UNITED STATES  
NUCLEAR REGULATORY COMMISSION  
WASHINGTON, D.C. 20555-0001

SAFETY EVALUATION BY THE OFFICE OF NUCLEAR REACTOR REGULATION  
RELATED TO AMENDMENT NO. 136 TO FACILITY OPERATING LICENSE NPF-35  
AND AMENDMENT NO. 130 TO FACILITY OPERATING LICENSE NPF-52  
DUKE POWER COMPANY, ET AL.  
CATAWBA NUCLEAR STATION, UNITS 1 AND 2  
DOCKET NOS. 50-413 AND 50-414

# ICE CONDENSER CONTAINMENT

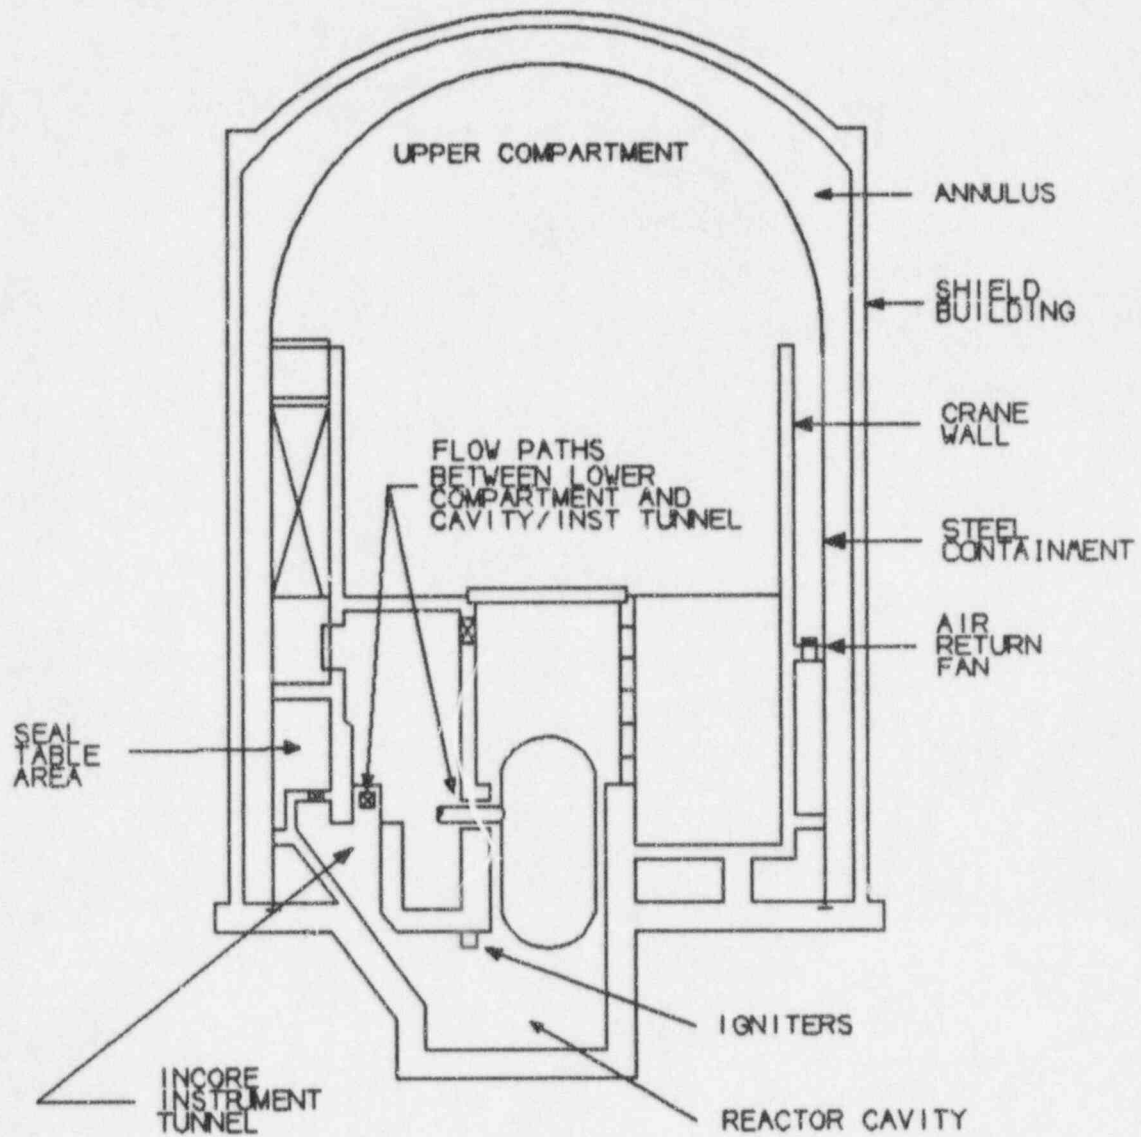
By letter dated April 10, 1995, Duke Power Company, et al. (DPC or the licensee), submitted a request for changes to the Catawba Nuclear Station, Units 1 and 2, Technical Specifications (TS). The requested changes would revise the required number of operable hydrogen igniters to allow removal of two hydrogen igniters serving the lower reactor cavity and incore instrument cable tunnel. These igniters are located in a high radiation area which poses an occupational exposure problem. The licensee has provided an analysis indicating that these two igniters are unnecessary. The attached figure depicts the location of the pair of igniters which are the subject of this evaluation.

The staff gave careful consideration to the igniter selection as part of its review. The original computer models used by the staff and applicants did not model the cavity/instrument tunnel space as a separate compartment. A detailed description of the McGuire and Catawba igniter systems, including discussions of background experiments, analyses, and research, is provided in "An Analysis of Hydrogen Control Measures at McGuire Nuclear Station", Revision 16, transmitted by letter dated August 5, 1993, from M. S. Tuckman, DPC, to the NRC, a three-volume document known as the "Redbook." The igniter system at Catawba consists of 72 glow plug igniters arranged in two trains. Each protected area is served by two independently powered igniters (Ref: DPC response to the July 21, 1981, NRC Request for Additional Information). All compartments are provided with direct igniter coverage. According to the Redbook, the McGuire and Catawba igniter systems are identical except for minor differences in terminal box designation and igniter location (but not total number). Additional igniters are provided that are not included in the Sequoyah/Watts Bar/D.C. Cook facilities, each of which have 68 igniters. The pair of igniters that the licensee has requested to eliminate at Catawba are among those. (See attached figure)

The Catawba Hydrogen Mitigation System (HMS) was designed to provide direct hydrogen igniter coverage for all compartments in the containment (Ref: Redbook 3.4). This was a licensee initiative that resulted in the installation of additional igniters at Catawba and McGuire located in an area not included in the Sequoyah lead HMS design. (The HMS at Sequoyah was reviewed as the "lead HMS design".) As noted above, the locations of concern for this review were not identified as being separate compartments or locations and were treated and analyzed as being contiguous portions of the lower containment area. The containment arrangements of the Tennessee Valley Authority and DPC ice condenser facilities are sufficiently similar that the approved Sequoyah locations, as described in the aforementioned Sequoyah SER, are considered sufficient with respect to mitigation of hydrogen combustion scenarios encompassed by the hydrogen rule. Based on the results of the original lead HMS review, the existing pair of igniters located in the lower reactor cavity can be removed from the required operability list.

Based on the information provided above, the results of the lead HMS review, and the licensee's supporting information, the staff concludes that the pair of igniters installed in the lower reactor cavity need not be required to be operable.
